Planning Commission Staff Report

Project Type:	Amended Architectural Elevations
Meeting Date:	February 23, 2015
From:	Purvi Patel Project Planner
Location:	North Outer 40 Road, east of Boone's Crossing
Applicant:	DosterUllom, LLC, on behalf of Taubman Prestige Outlets of Chesterfield, LLC
Description:	<u>Chesterfield Outlets (H&M) 3rd AAE:</u> Amended Architectural Elevations and Architect's Statement of Design for a 48.625 acre tract of land zoned "PC" Planned Commercial District located on the north side of North Outer 40 Road, east of Boone's Crossing.

Taubman Prestige Outlets Planning Commission Submittal

Figure 2 – Building M South Elevation (facing Highway I-64)

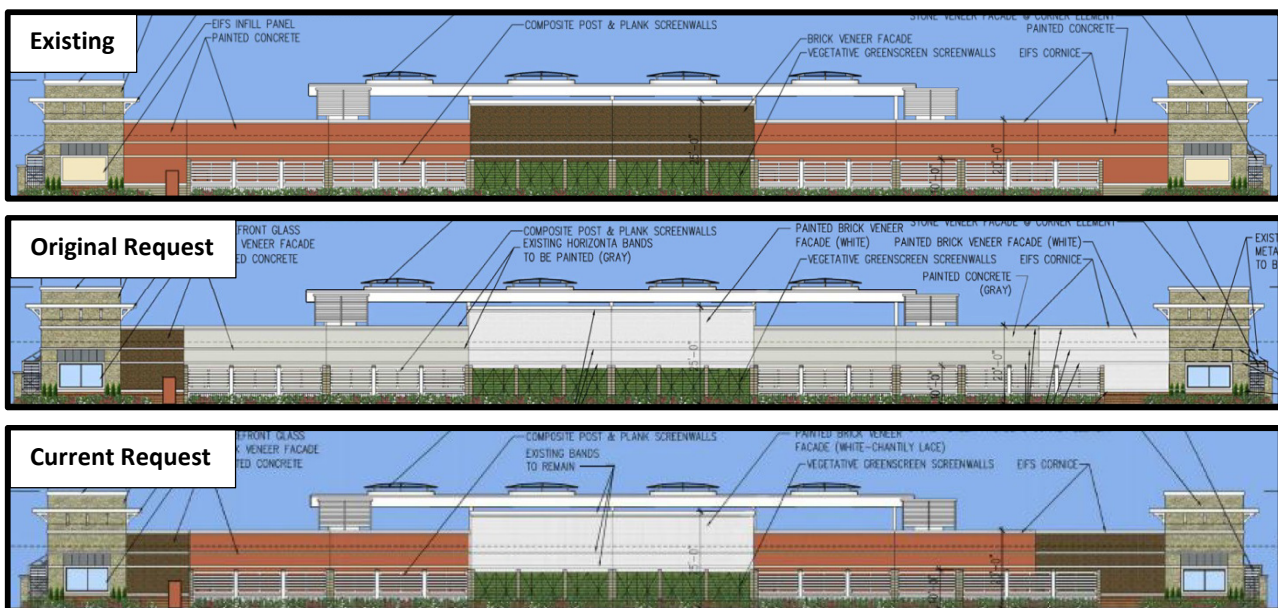
When presented to the ARB, the applicant proposed a change to the colors of the brick veneer panels and the adjacent terra cotta panels to a “White-Chantilly Lace” and “Gray Owl” color. The color change was proposed for the majority of this façade and was not in keeping with the architectural rhythm of the center. However, the updated proposal is now for only 23% of the façade and includes just one color. Below are images showing the existing elevation, the elevation proposed to ARB and the current request:

Figure 3 – Building M North Elevation (facing interior pedestrian walkway)

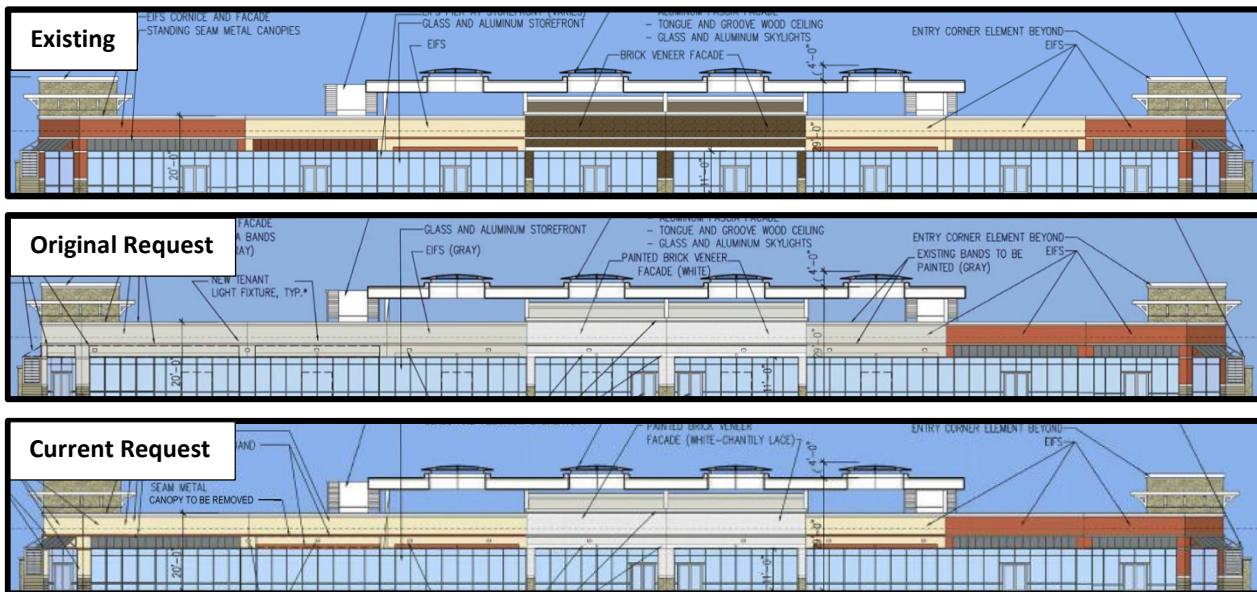
The changes proposed for the north elevation include extending the beige EIFS with terra cotta accent bands further north along the façade (over the existing terra cotta color). This proposed color change which will wrap around to the east elevation of Building M as well. The second request is the painting of the brick veneer to the “White-Chantilly Lace” color similar to the south elevation. When presented to the ARB, the proposal was to paint all of the EIFS storefront the “Gray Owl” color and the brick veneer “White-Chantilly Lace”. As seen in the images below, the color palette presented now is in keeping with the overall theme of the center. Furthermore, these colors are hard to see and differentiate at the human scale along the storefront, which is the case all along the interior pedestrian mall of this center.

Figure 4 – Building M East Elevation (facing mall entrance corridor, between Buildings M & N)

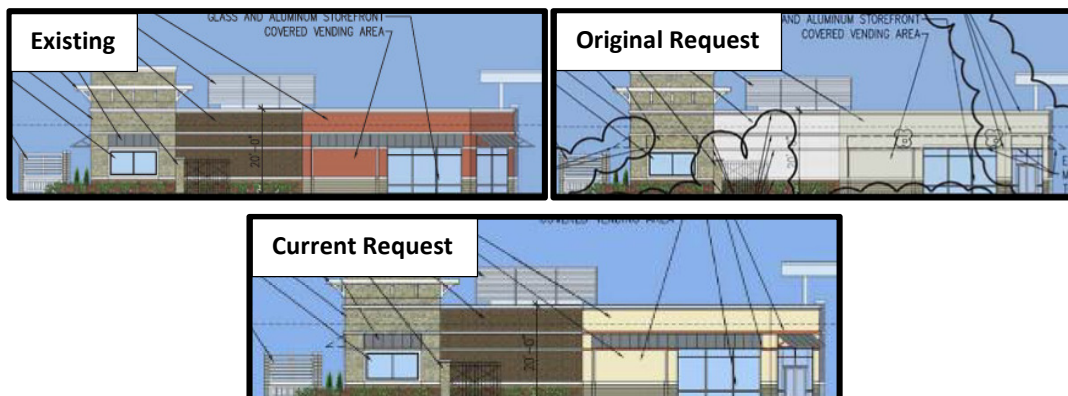
As mentioned above, the beige EIFS with terra cotta accent bands will extend onto the east elevation from the north elevation for approximately 50 feet. This would replace the existing terra cotta EIFS panels. The request before ARB was to paint the terra cotta EIFS and brick veneer to a “White-Chantilly Lace” and “Gray Owl” color, but the updated request is to use existing colors on only a portion of the façade. There are no changes requested to the brick veneer and stone veneer on this elevation.

Figure 5 – Standing Seam Metal Awnings

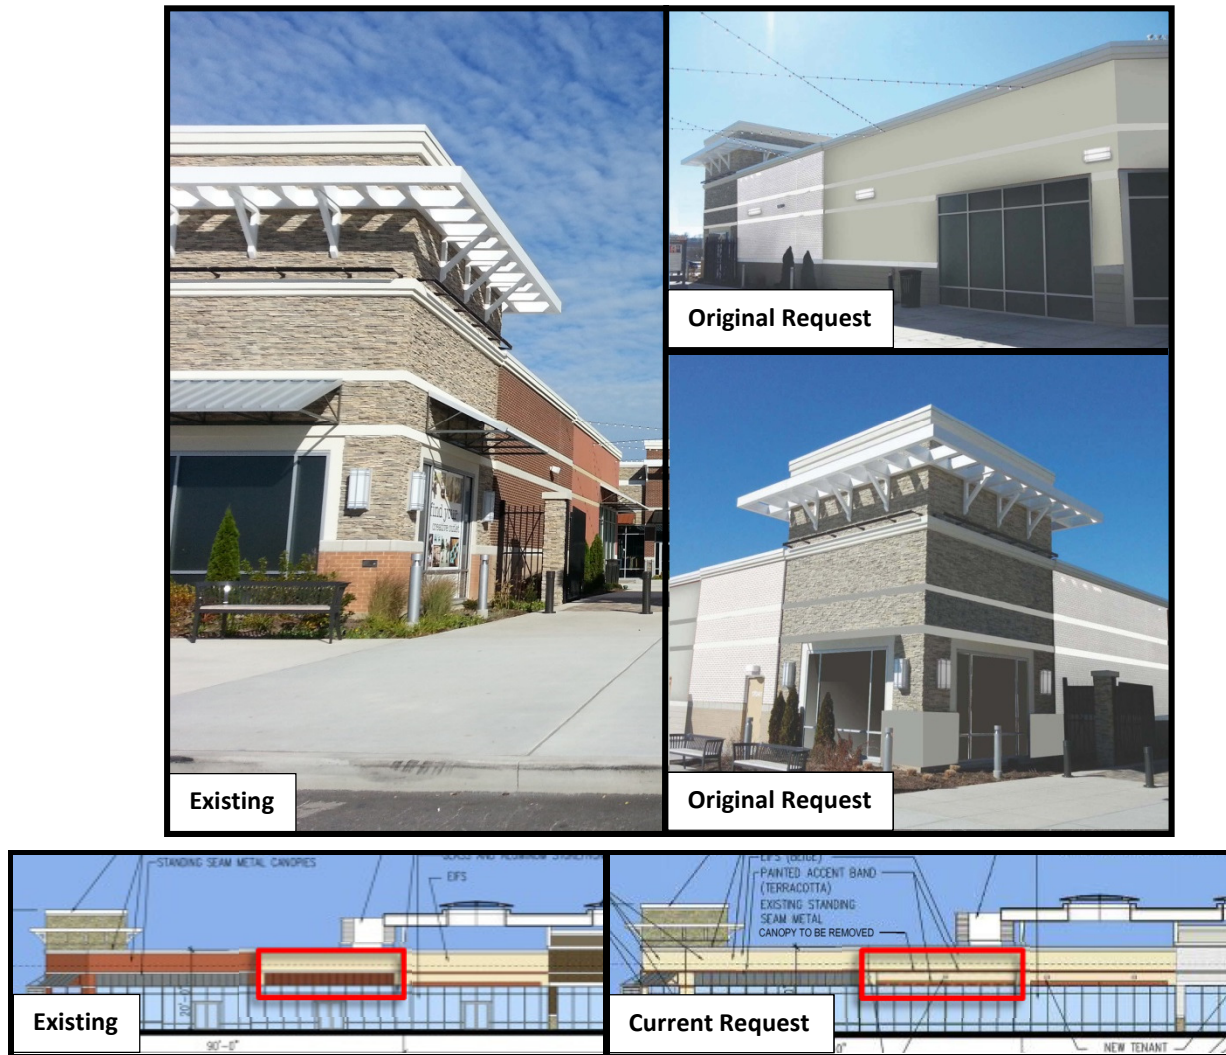
The second change proposed is the removal of one standing seam metal awning located on the north elevation of Building M; all other awnings would remain. The Architect's Statement of Design notes the removal of this awning is to accommodate the tenant's desire to maintain clean lines.

The request as presented to the ARB was for removal all awnings along the tenant's storefront, as well as the south and east elevations as seen below in Figure 5. Since the ARB meeting, the applicant changed their request and is now proposing the removal of only one awning on the interior north façade. This awning is highlighted in red in the image below.

SHEET NUMBER
A2.05

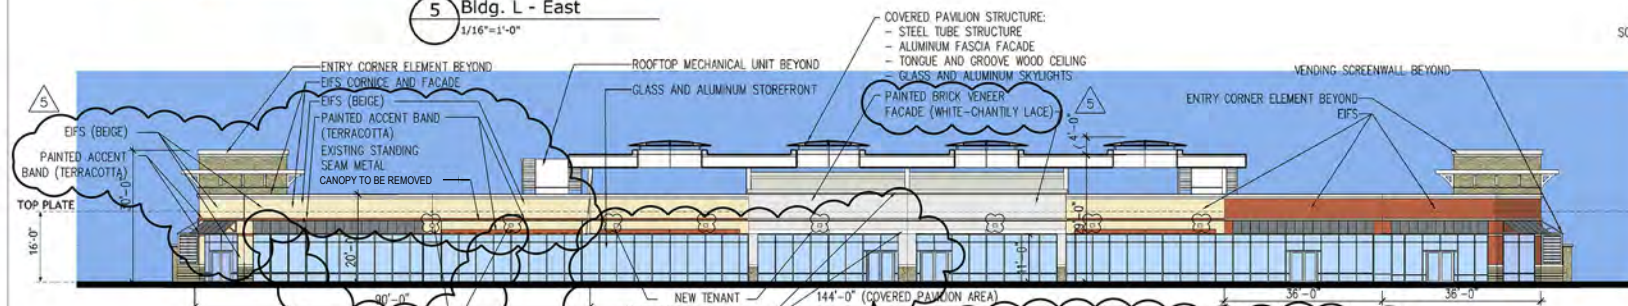
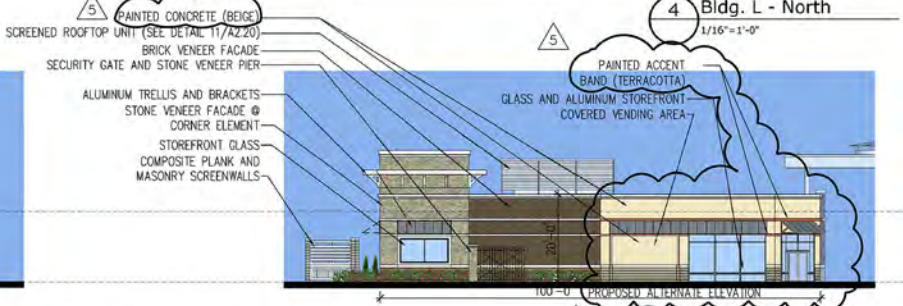
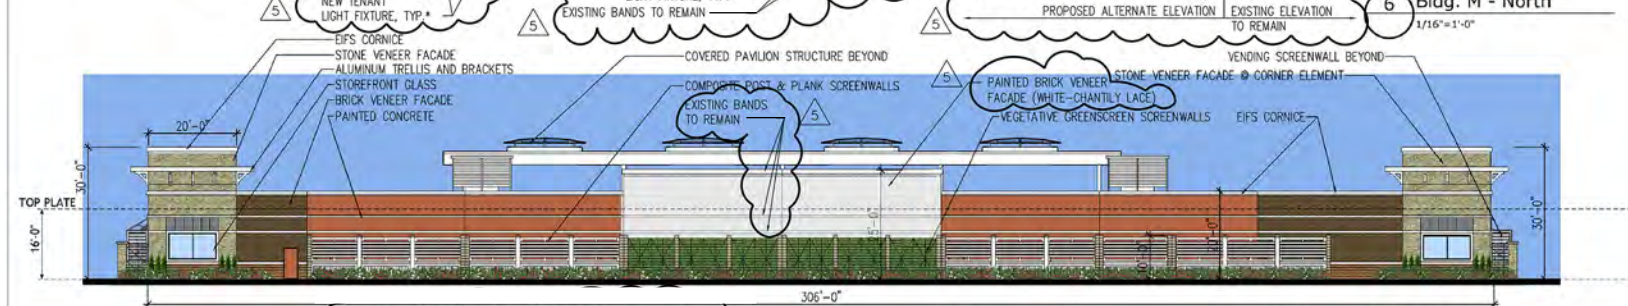
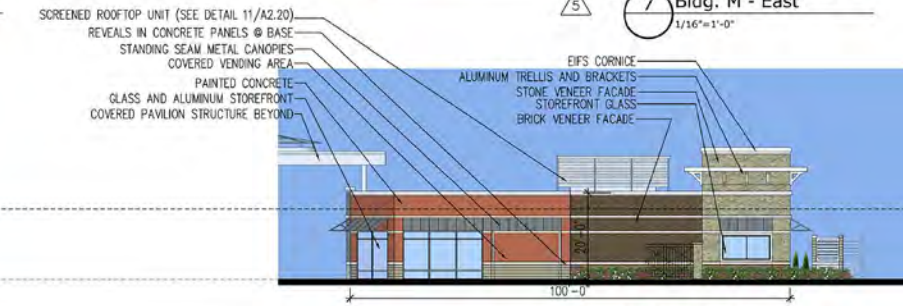
- The proposed changes to the Building “M” façade, as shown on sheet A2.05, are to accommodate a significant new tenant at the shopping center. As such, we worked with the Tenant and their architect to ensure we address the Chesterfield Architecture Review Board’s comments and maintain the previously approved General Requirements for Building Design. The proposed modifications include the alteration of the existing exterior color scheme of a portion of the “M” building, the removal of a select building awning and the addition of new light fixtures. Approximately 72 linear feet along South façade (23%), 50 linear feet along the East façade (50%) and 173 linear feet along the North façade (53%) are impacted.
